Wednesday, November 3, 2021
Board of Commissioners Meeting - 7:00 PM

B. A Resolution Granting Preliminary Approval to a Major Plan Entitled "Ridge Farm"

TO: Planning Commission
FROM: Gregg Adams, Planner
DATE: August 13, 2021
SUBJECT: Subdivision Plan Review
 Ridge Farm
 Major Plan 2017-101
 Plan Dated May 19, 2021

Project: **RIDGE FARMS**
 Drawing Title: **MASTER UTILITY PLAN**
 SOUTH WHITEHALL TOWNSHIP
 LEHIGH COUNTY PENNSYLVANIA

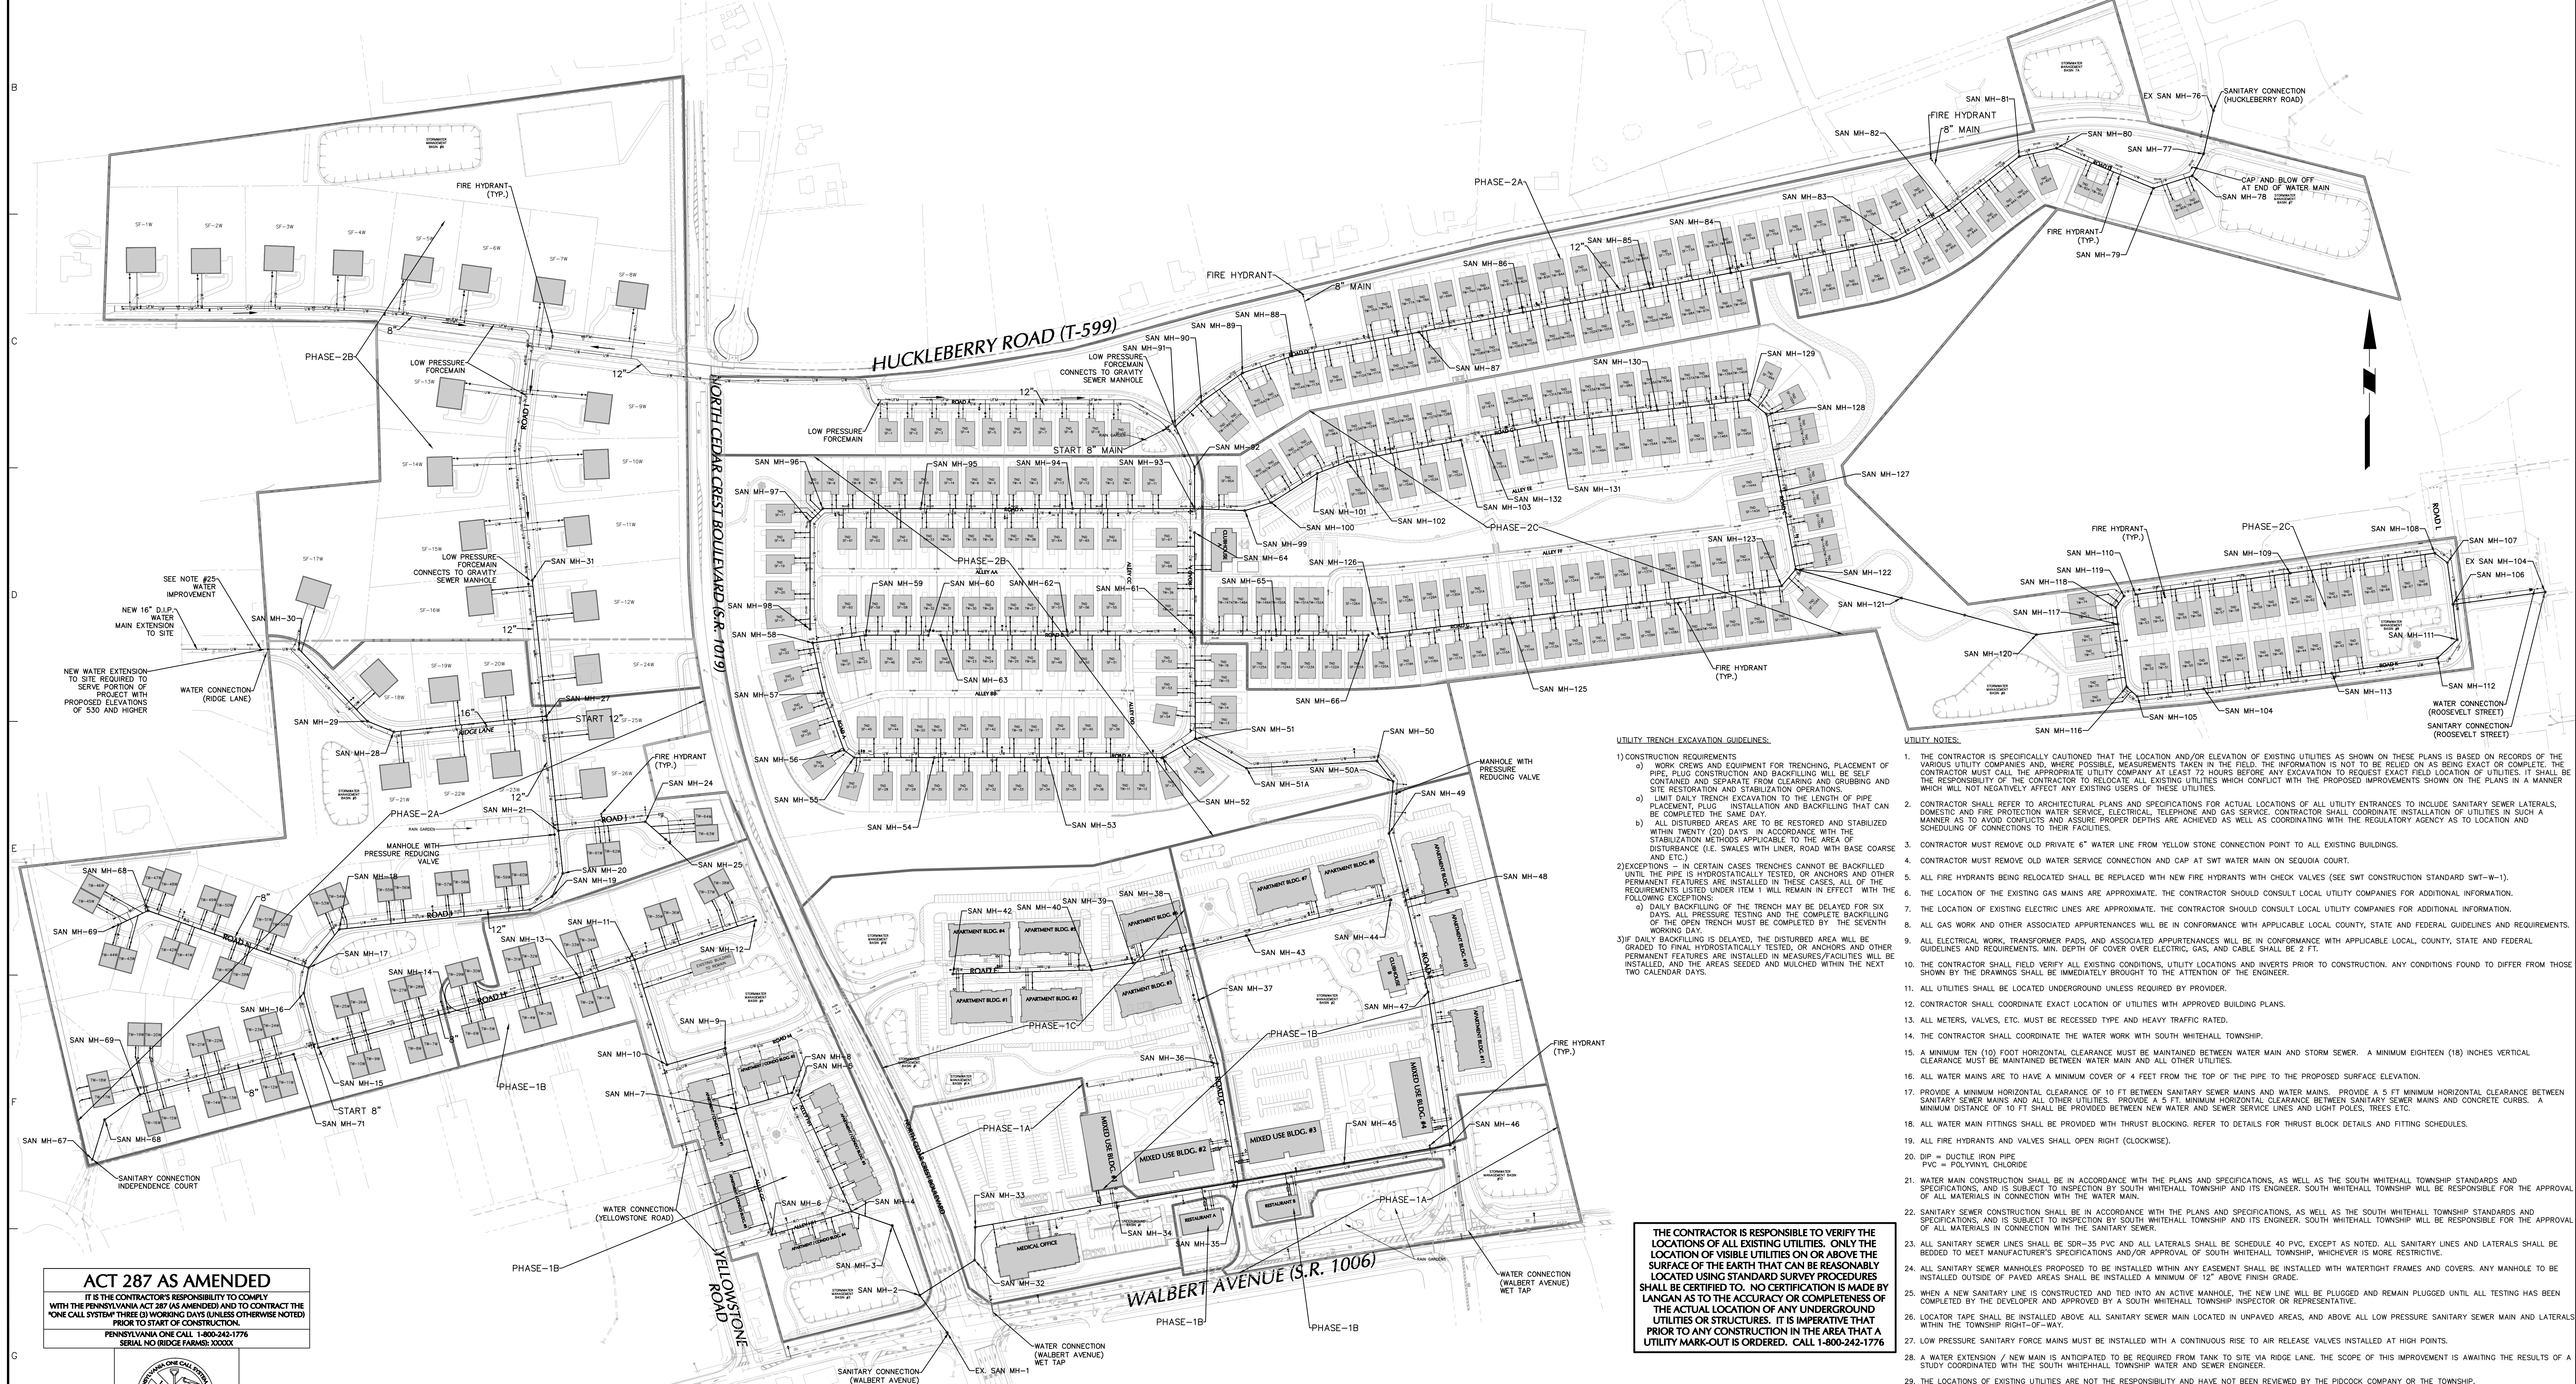
1. Sheet 7 Drawing VT-103 Existing Features: Must show private 6" water line from Yellow Stone Rd to all existing buildings.
2. Sheet 86 CU-100 ADD to NOTES:

Project No: 240043301
 Date: 10/06/2020
 Scale: 1" = 150'
 Drawn By: SPW
 Checked By: NB
 Submission Date: _____
 Drawing No: **LP-100**
 Sheet 128 of 151

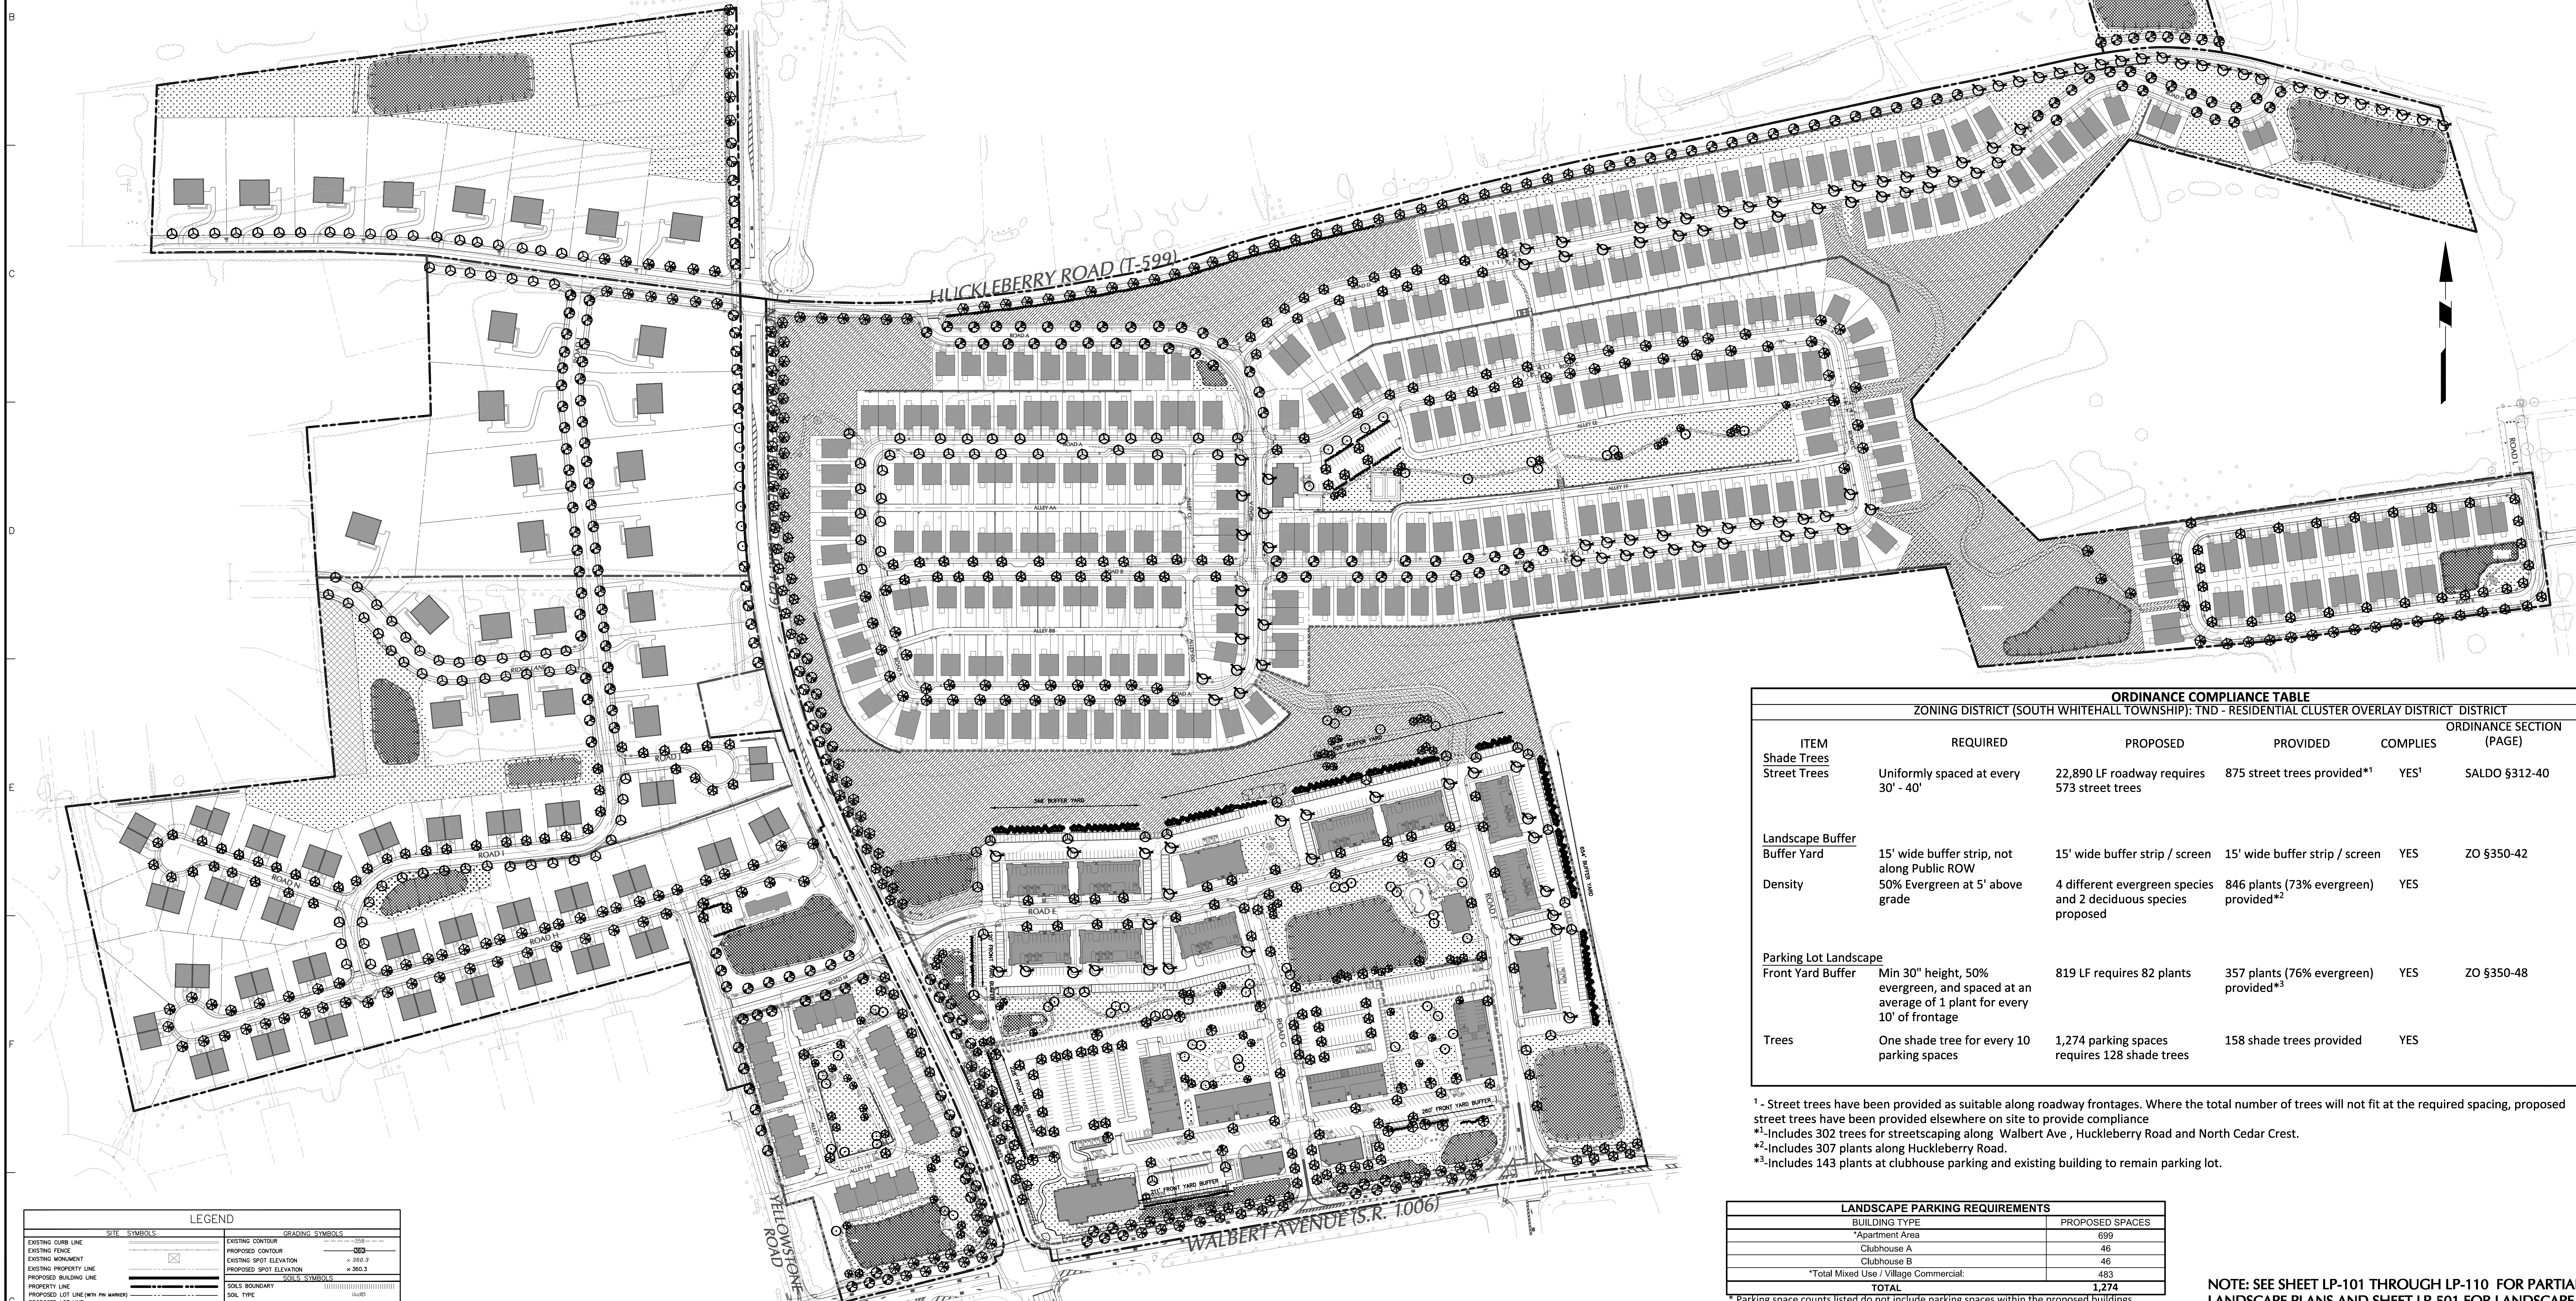
- 4.2.a. Per Appendix C of the SWT ZO, Design Standard 13.5 indicates that the Streetscape shall be embellished with street trees and street lights, and enhanced with other street furniture and amenities. Road G is a main ingress/egress into the proposed TND from Walbert Avenue. The Landscape Plan (Sheet 113/LP-100) does not depict any street trees for the Streetscape along Road G.
